**RE: Murphy Express – Cottonwood
 3751 Hwy 528 NW
 Permanent C.O. - Accepted
 Engineer's Certification Dated 03/25/19
 Engineer's Stamp Date: 05/09/18
 Hydrology File: A14D003A**

Project Murphy Oil - Albuquerque NM
Project # 20160897.0
Re Response to TCO Letter dated 5/8/2019

The following is our response to your TCO Letter dated 5/8/2019:

AS-BUILT DRAINAGE
BASIN TO DETENTION
POND = 0.92 ACRES

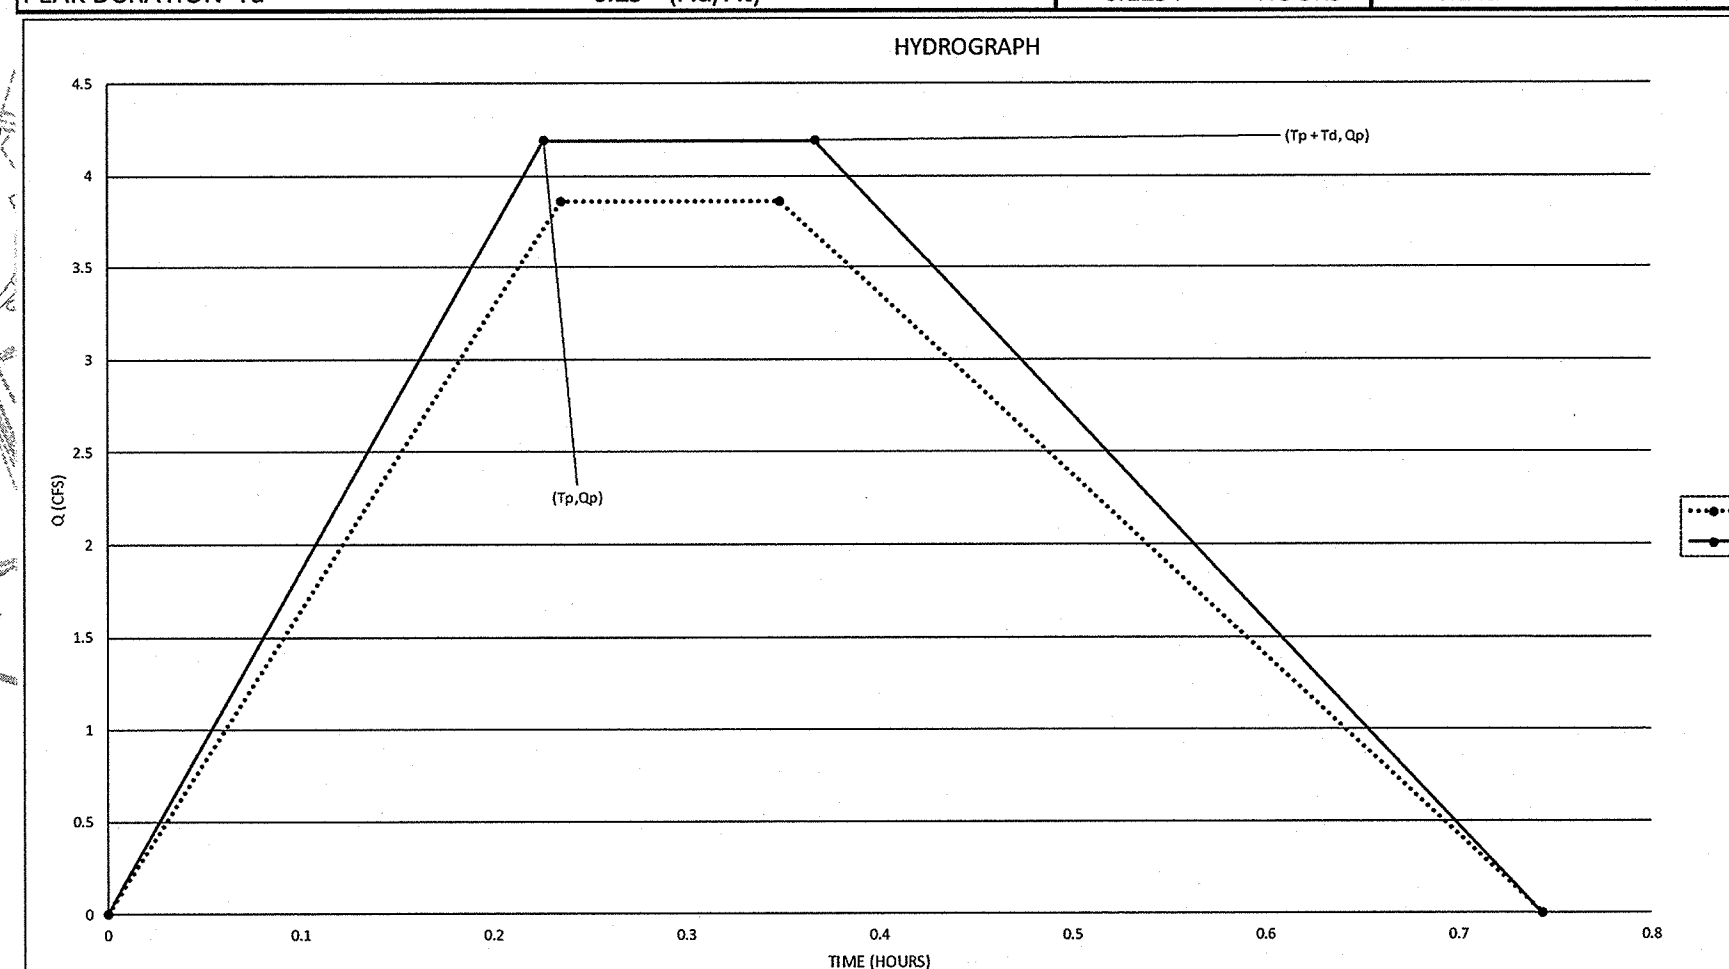
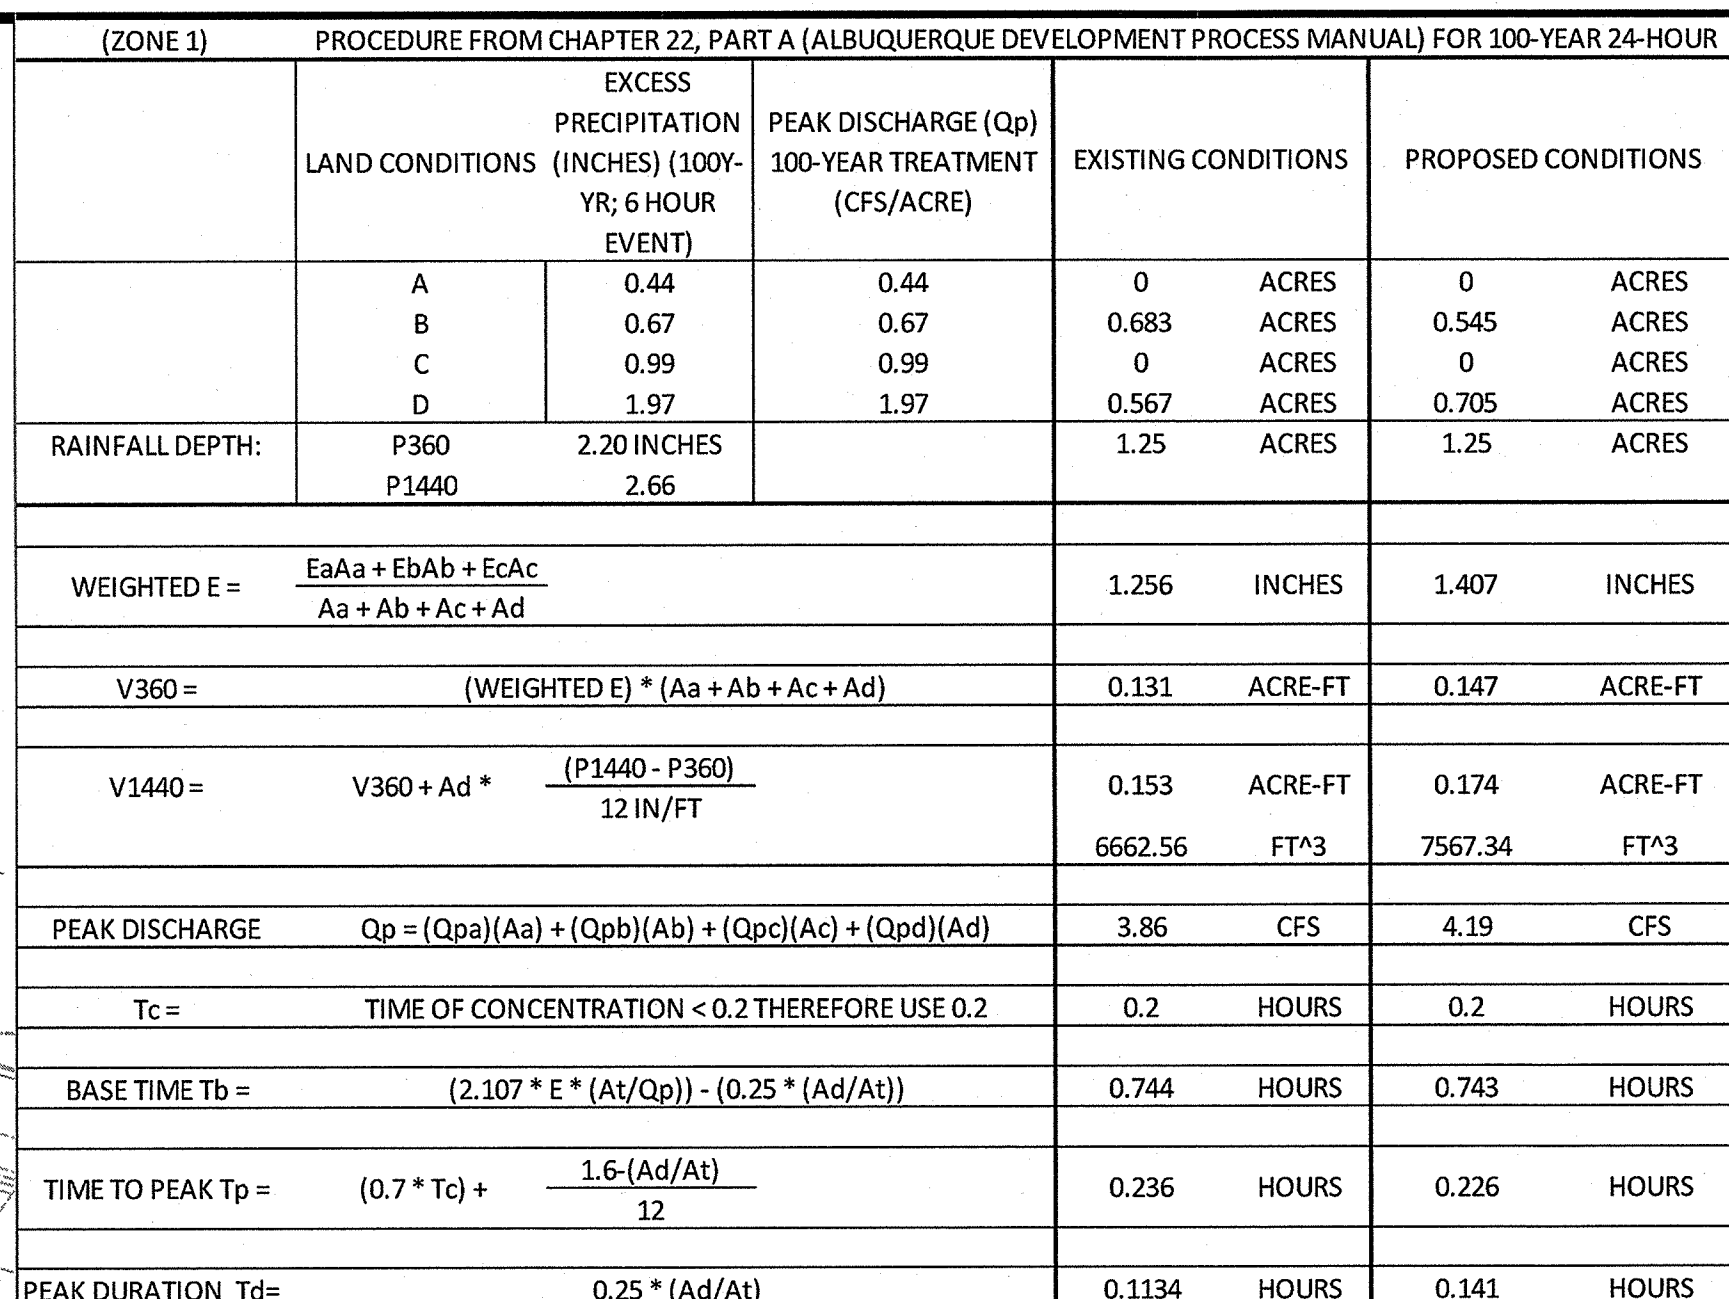
5. *Outline the as-built drainage basin(s) (including roof areas) supported with sufficient spot elevations and roof drain locations.*

a. *Pond(s) (include as-built volume calculations)*

Response – See enclosed As-built Drainage Basin Map. It is our professional opinion that the drainage basin area sufficiently meets the requirements of the approved design plans.

Response – See enclosed As-built Drainage Basin Map for Detention Pond Chart
